V2500-A5 SERIES PROPULSION SYSTEMS SERVICE BULLETIN

V2500-ENG-72-0584
Transmittal - Page 1 of 1

ENGINE – LP COMPRESSOR – TO APPLY THE MULTI-RATING ENGINE IDENTIFICATION PLATE TO ALL
A5 ENGINE MODELS

Before and after alteration of the Engine Identification Plate
Figure 2

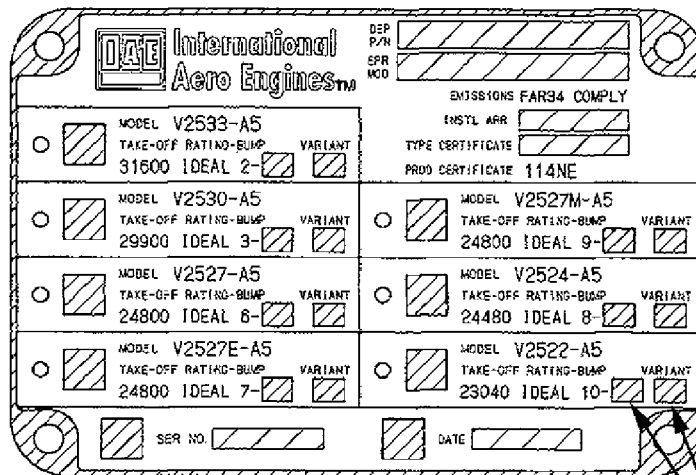
Current multi-rating Engine Identification Plate can not be used on SelectOne™ Engines or Bump Rated Engines because Data Entry Plug (DEP) Variant and Bump Rating Index are initially marked on the Engine Identification Plate.

(a) New Engine Identification Plate has the blanks for marking of Data Entry Plug (DEP) variant and Bump Rating. (Refer to Figure 2)

(2) Existing Engine Identification Plate, P/N 5A1875 can not be reworked to the new Engine Identification Plate because DEP variant and Bump Rating Index are initially marked on the existing Engine Identification Plate and they can not be rewritten.

BEFORE ALTERATION (P/N 5A1875)

AFTER ALTERATION (P/N 5A1942)

Blank for marking of DEP
Variant and Bump Rating

Replacement of the Engine Identification Plate
Figure 3

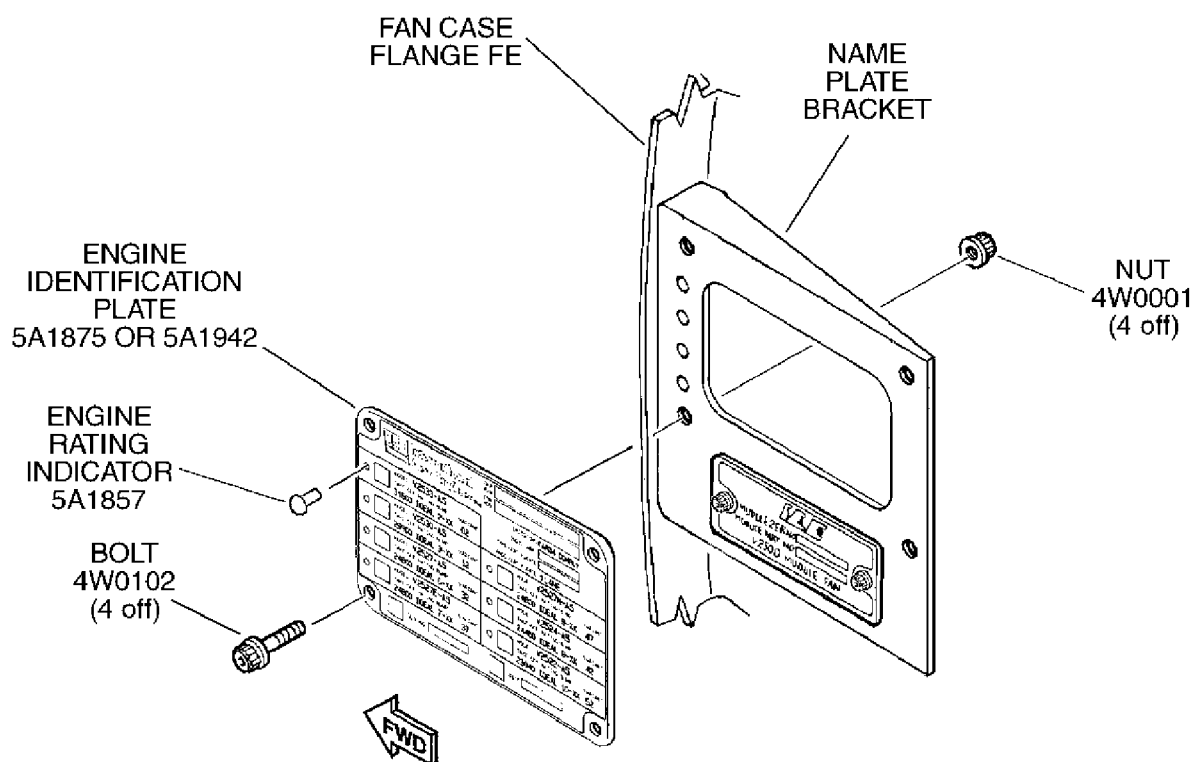
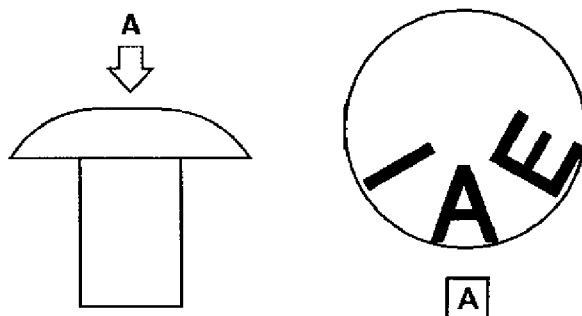
- (a) Remove the four bolts, P/N 4W0102 and the four nuts, P/N 4W0001 that hold the Engine Identification Plate to the bracket.
- (b) Permanently deface the old Engine Identification Plate, P/N 5A1875 and return it to your IAE International Aero Engines AG representative. Engine Model and Serial Number must retain visible in order to allow verification by IAE Quality Assurance. Recommended technique is to vibropeen a wavy line through the Type Certificate and Production Certificate Numbers.

- (c) Get the new Engine Identification Plate from your IAE International Aero Engines AG Representative.
 - (d) Mark the Engine Identification Plate with the appropriate Take-Off Rating-Bump No. and Variant No.. (Refer to SPP 70-09-00, Procedure to make Permanent Identification and Location Marks and Figure 3 and 4). Use the vibration peen method.

- (g) Install the re-usable Engine Identification Plate and the bracket as per Reference (1), Service Bulletin V2500-ENG-72-0378.
 - (i) Install the new Engine Identification Plate, P/N 5A1942 with the four bolts, P/N 4W0102 and the four nuts, P/N 4W0001.

- (ii) Torque the four bolts between 36 - 45 lbfin. (4,0 - 5,0 Nm).
 - (h) Make sure that the work area is clean and clear of tools, equipment and other unwanted materials.

Replacement of the Engine Rating Indicator
Figure 4

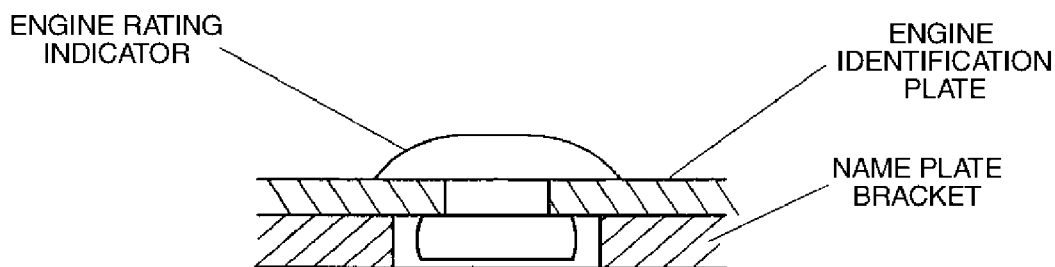
- (e) Get the Engine Rating Indicator (73-22-36, 01-100), P/N 5A1857 (IAE Rivet) and attached.
 - (f) Install the Engine Rating Indicator, P/N5A1857 (IAE Rivet) in the Engine Identification Plate at the appropriate 'TAKE-OFF RATING/VARIANT' position.

- (i) Drill a hole 0.098 - 0.101in. (2,5 - 2,56 mm) diameter at the circle marked on the Engine Identification Plate at the designated rating, and deburr the hole.

- (ii) Install the Engine Rating Indicator, P/N 5A1857 (IAE Rivet) through the Engine Identification Plate, P/N 5A1875 at the designated rating and squeeze with the power riveter.
